ADDENDUM #3

Project	Nelson H.S. Renovations	Project No.	2323
Location	4181 New Street, Burlington, Ontario	Date of Issue	2024 05 31
Owner	The Halton District School Board	File	2323/7.1.3

This Addendum forms part of the Contract Documents and amends the original Drawings and Specifications, dated 2024 05 13, as noted below.

FIRST FLOOR PLAN

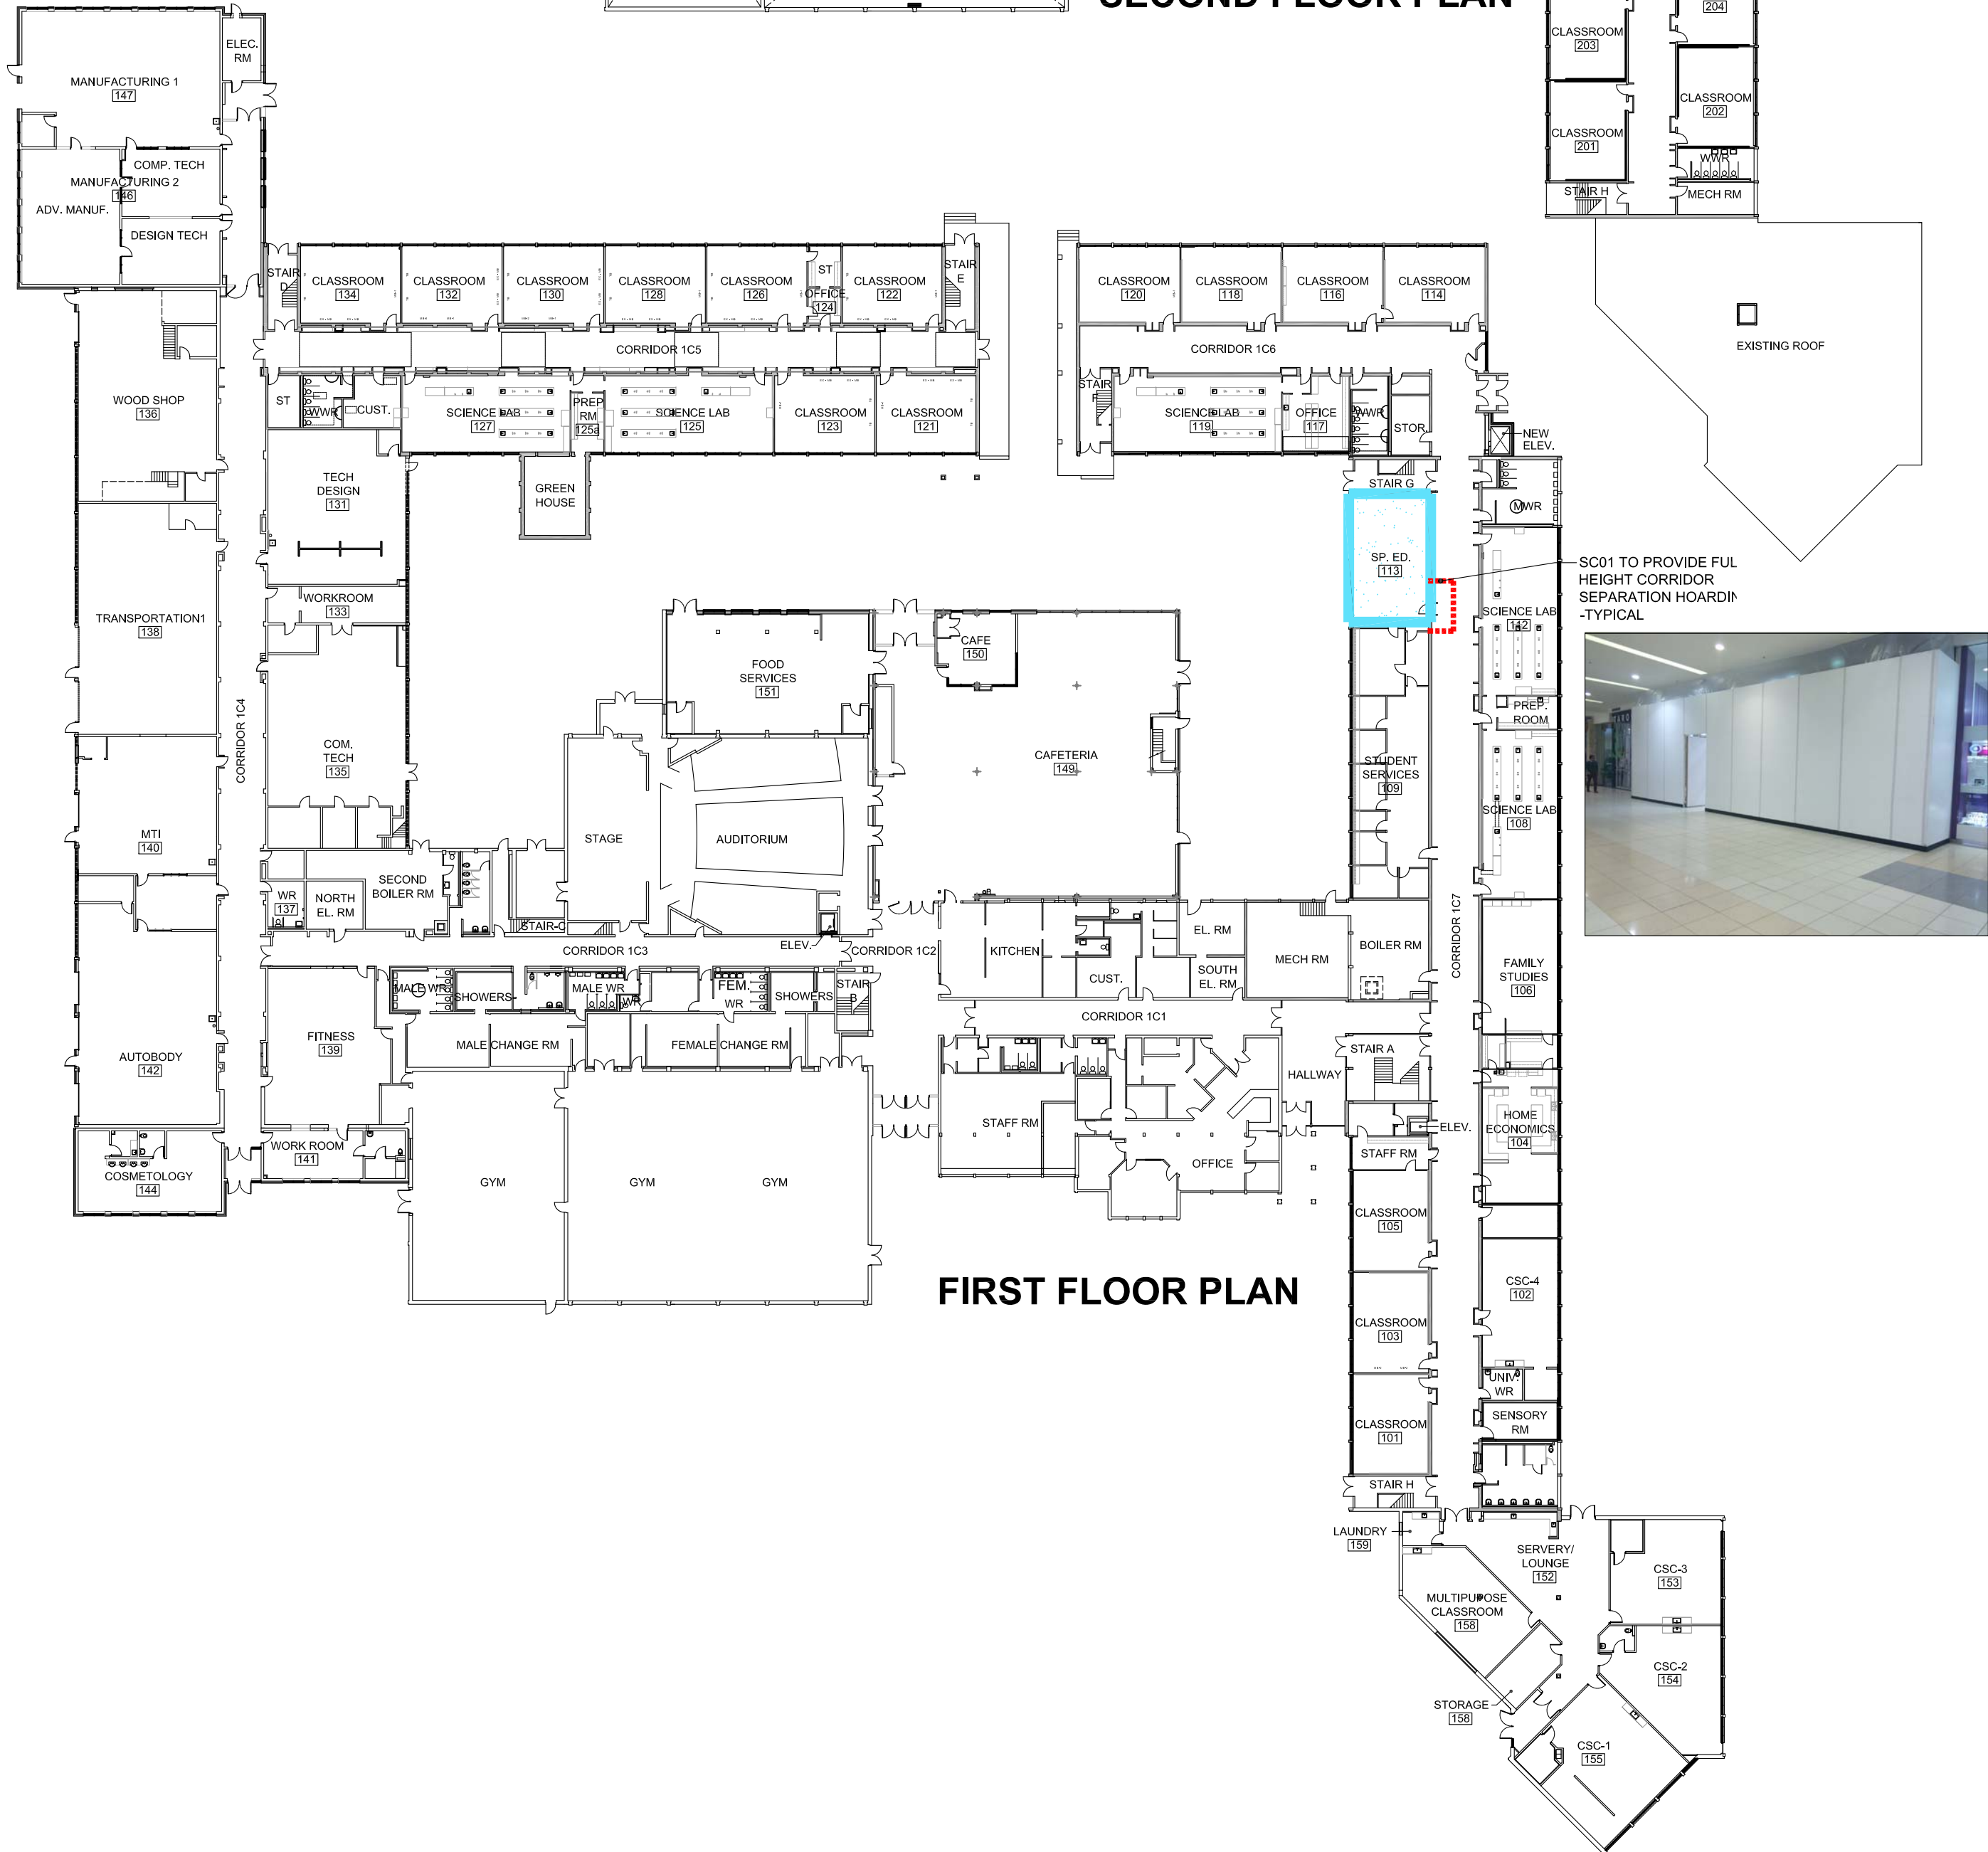
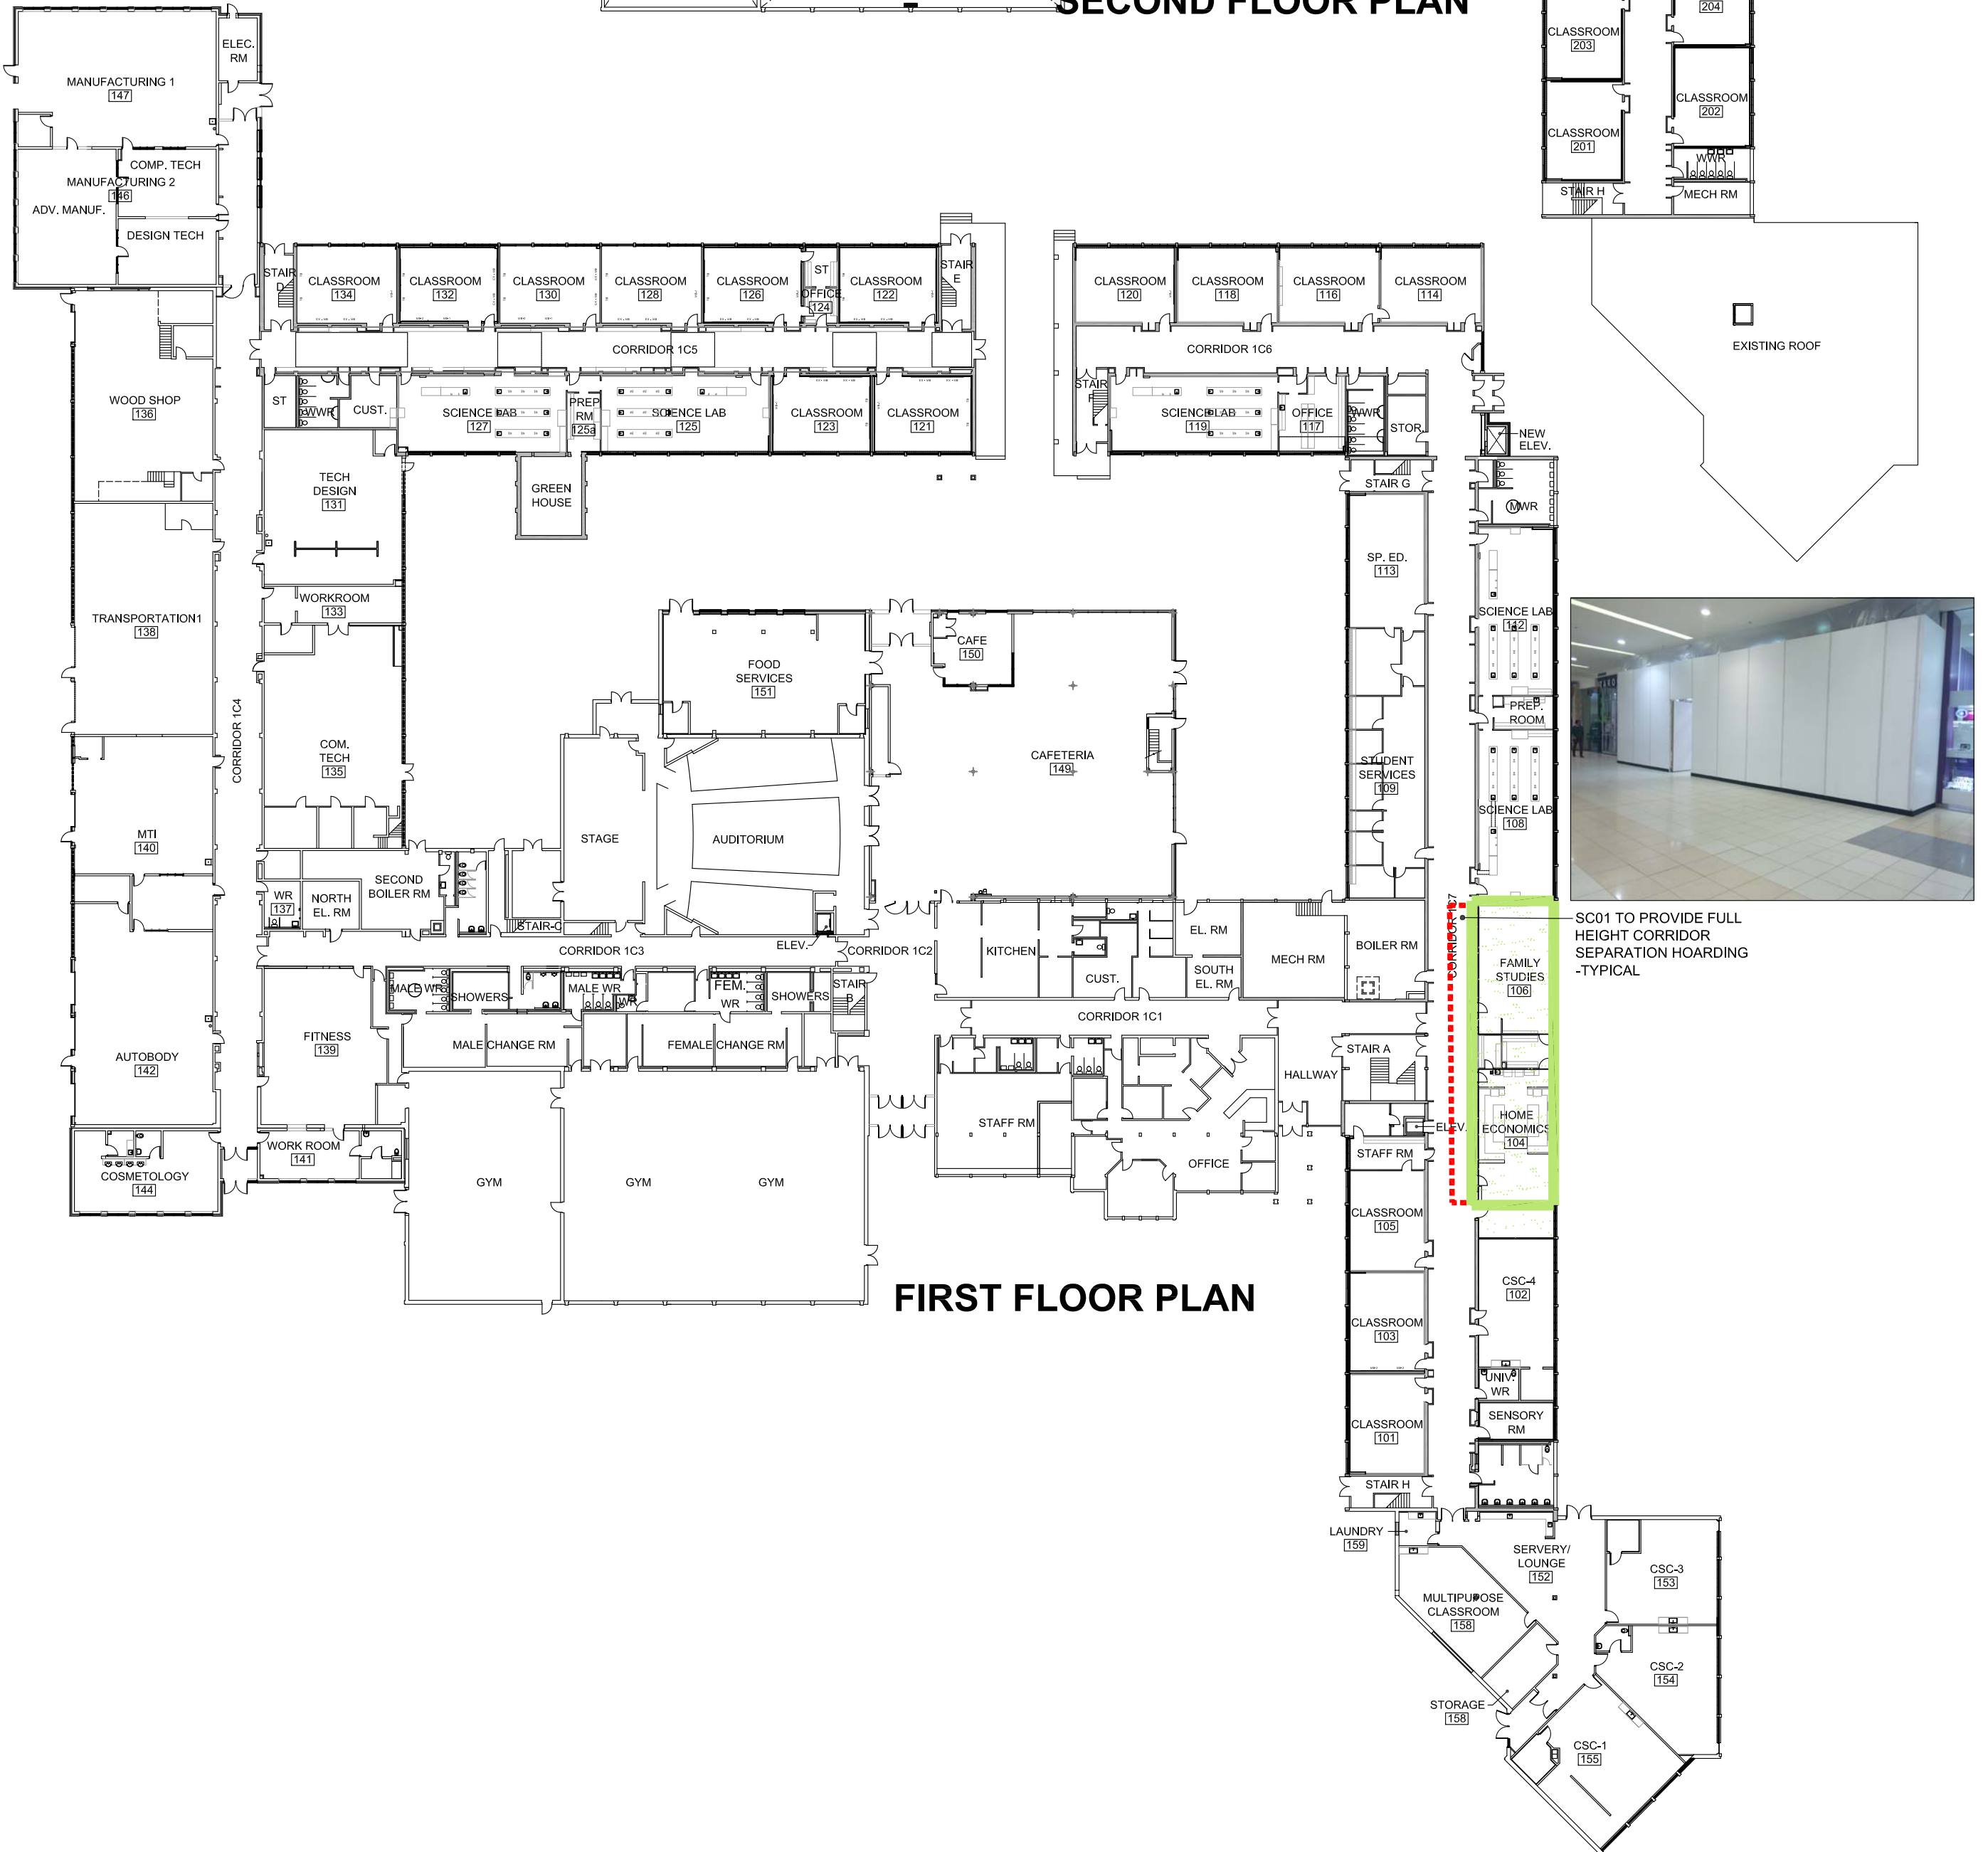
A3-1 DRAWING A104 CONCEPTUAL IMPLEMENTATION AND PHASING PLANS (issued)

- .1 Add missing drawing

1 1959 CLASSROOM WING - SECOND FLOOR PARTIAL RENOVATION PLAN

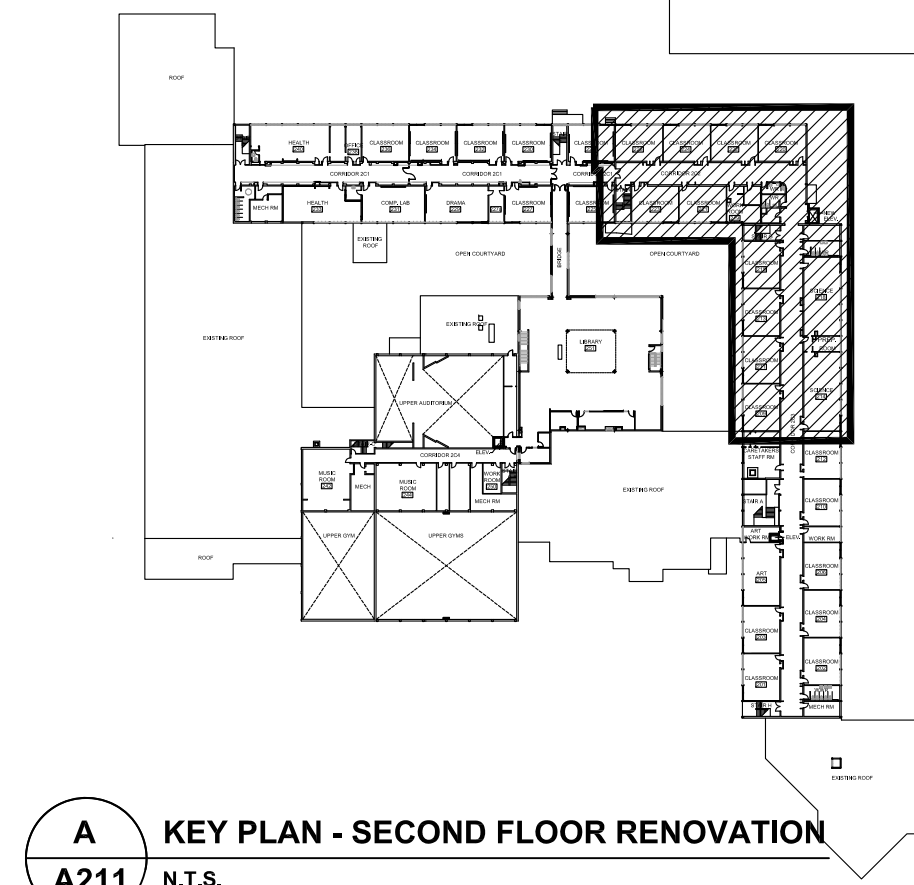
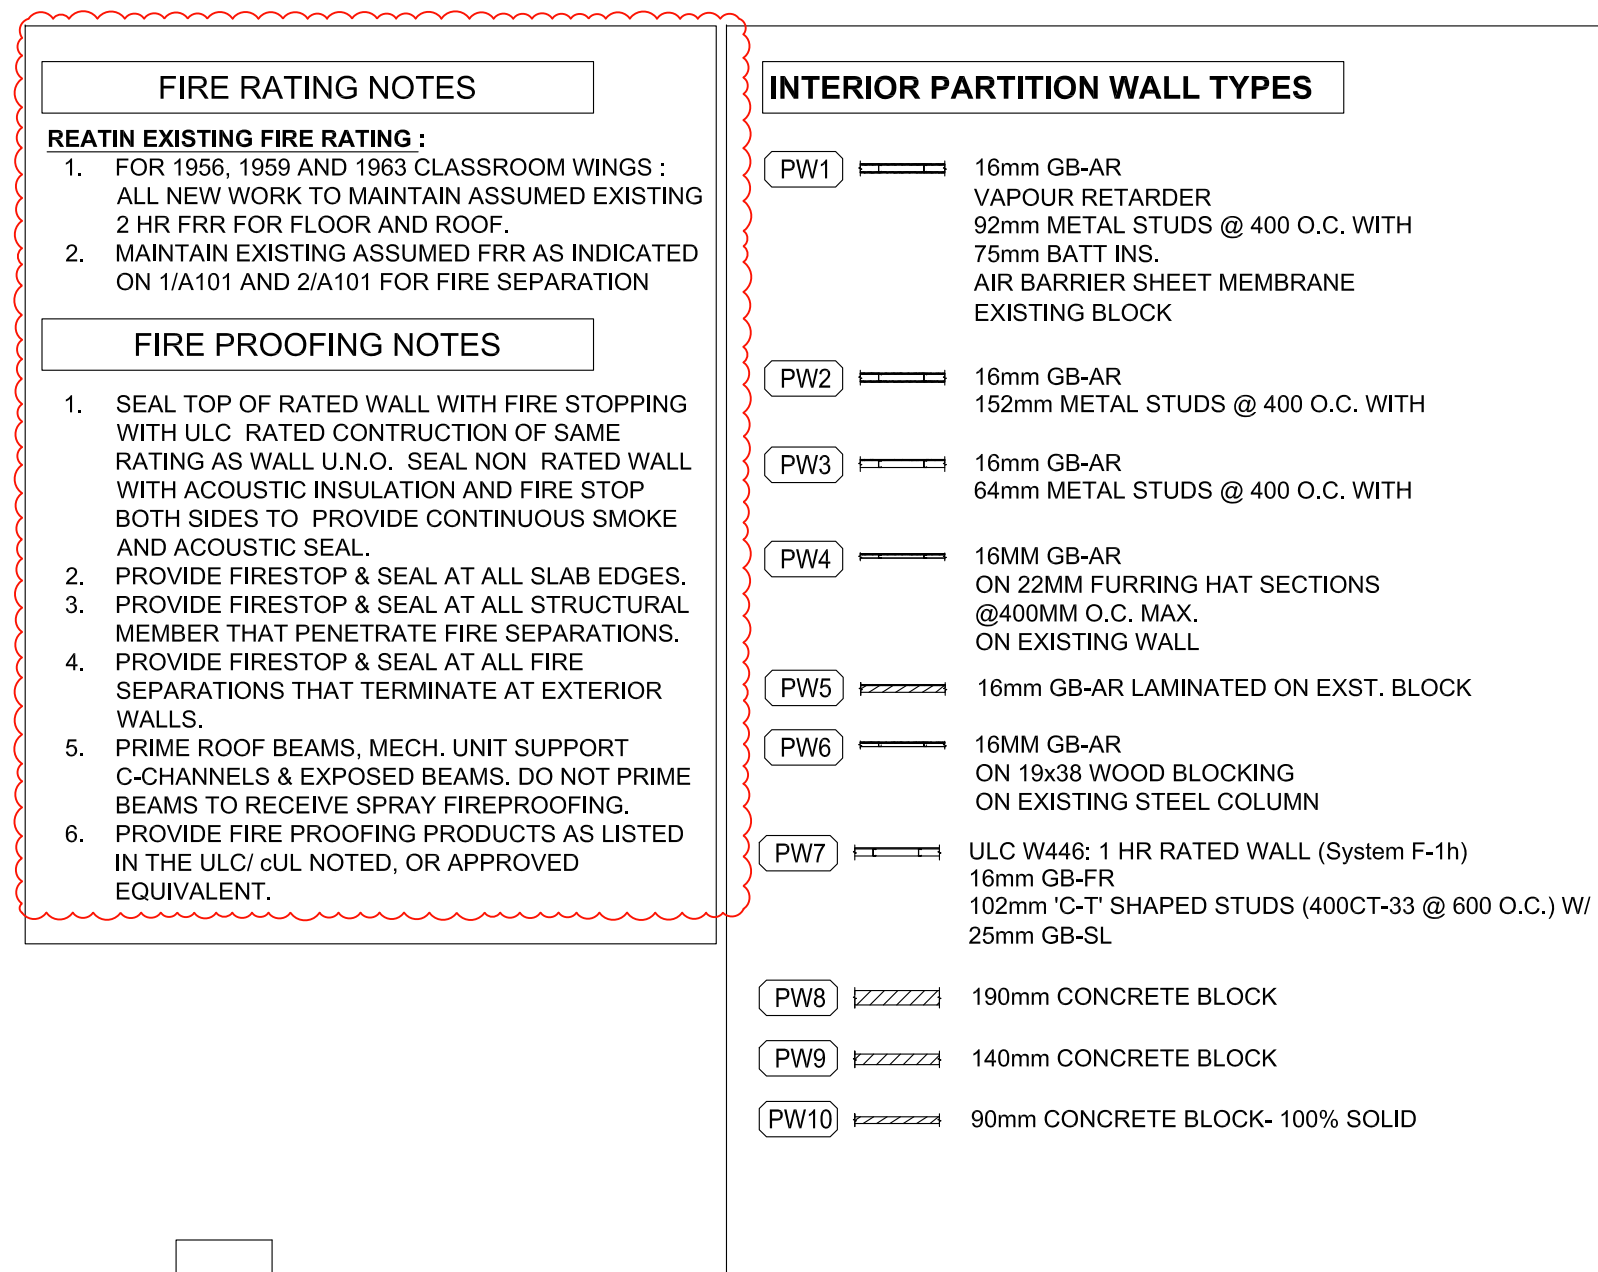
A3-5 DRAWING A211 SECOND FLOOR PARTIAL RENOVATION PLANS (reissued)

- .1 Replace drawing with re-issued drawing
- .2 Add Fire Rating Notes and Fire Proofing Notes
- .3 Replace Renovation note no. 3 and 18
- .4 Add Renovation note no. 9a, 24, 25, 26, 27 and 28
- .5 Add Renovation note no. 18 in Rms. 220, 222, 223, 224 and 226
- .6 Add Renovation note no. 3 in Rm. 215
- .7 Add Renovation note no. 9a in Rm. 218
- .8 Add Renovation note no. 11 in Rm. 214
